BID PROJECT NO. 1102-12

COUNTY OF MONROE
DEPARTMENT OF TRANSPORTATION

ADDENDUM NO. 2

IMPROVEMENTS TO PORTLAND

UNDERDRAIN DETAIL - WITH CONCRETE GUTTER

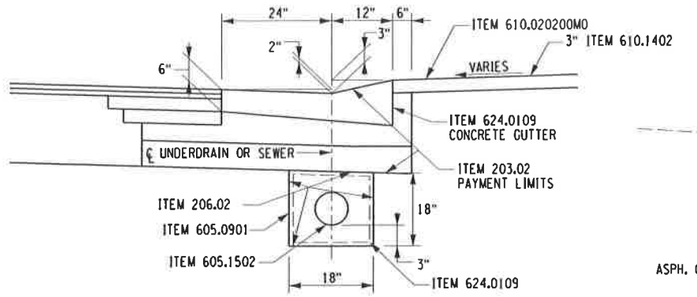
CLARIFICATIONS were made to the STORM SEWER WITH UNDERDAIN PIPE DETAIL and UNDERDRAIN DETAIL to better define trench width and pay limits for excavation and backfill. In areas where storm sewer is to be installed adjacent to the curb, the boxout excavation shall be paid for per the STORM SEWER WITH UNDERDRAIN PIPE DETAIL using Item 206.04. In areas where there is no storm sewer adjacent to the curb, the boxout excavation shall be paid for using Item 203.02 per the typical sections.
